# Access Compliance Report

## Public Rights-of-Way (Curb Ramps)

Intersection ID: 48503	Main Street: KELBURN_LN	Cross Street: CASTLECOVE_RD	Location: NE
ADA ID: 778710FC3B18	Ramp Type: PerpDiag	Initial Pass/Fail: Fail	Overall Compliance: No
Severity Score: 25			
Codes/Mitigation Info/Possible Solution		Field Measurements/Component Compliance

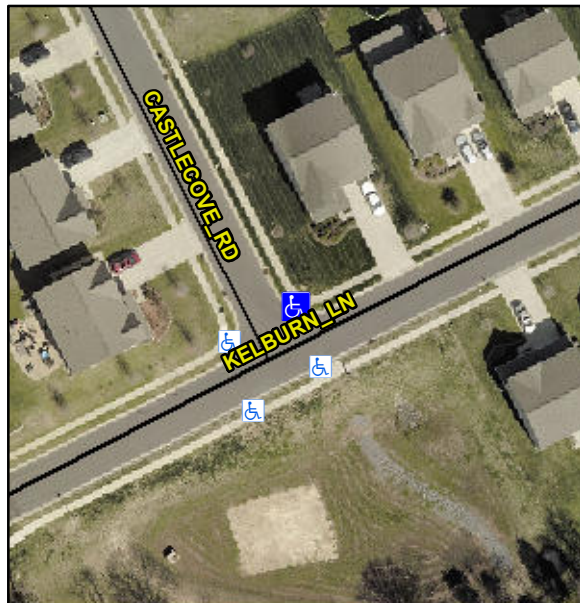
**R304.2.2, R304.5.3**

Compliance	Description	Data	Compliance	Description	Data
N/A	Ramp Length (in)	48.0	No	Ramp Slope (%)	8.7
Yes	Ramp Width (in)	48.0	No	Ramp XSlope (%)	5.1
N/A	Flare Type LT	N/A	N/A	Flare Type RT	N/A
N/A	Flare Slope LT (%)	N/A	N/A	Flare Slope RT (%)	N/A
N/A	Flare Traversable LT?	N/A	N/A	Flare Traversable RT?	N/A
N/A	Landing Length (in)	N/A	N/A	DWS Provided?	N/A
N/A	Landing Width (in)	N/A	N/A	DWS Contrast?	N/A
N/A	Landing Slope (%)	N/A	N/A	DWS Length (in)	N/A
N/A	Landing X Slope (%)	N/A	N/A	DWS Full Width?	N/A
N/A	Landing Curb? (Y/N)	N/A	N/A	DWS Offset (in)	N/A
N/A	Shared Landing?	N/A			
N/A	Gutter Ponding?	N/A	N/A	Gutter Slope (%)	N/A
N/A	Gutter Lip Ht (in)	N/A	N/A	Gutter X Slope (%)	N/A
N/A	Painted X Walk1?	No	N/A	Painted X Walk2?	No
	X Walk 1 Direction	To SW		X Walk 2 Direction	To SE
N/A	X Walk 1 Width (in)	N/A	N/A	X Walk 2 Width (in)	N/A
	X Walk 1 Slope (%)	0.1		X Walk 2 Slope (%)	2.6
	X Walk 1 X Slope (%)	2.1		X Walk 2 X Slope (%)	3.1

**Remove & Replace Curb Ramp With Two New Directional Ramps or Equivalent.**
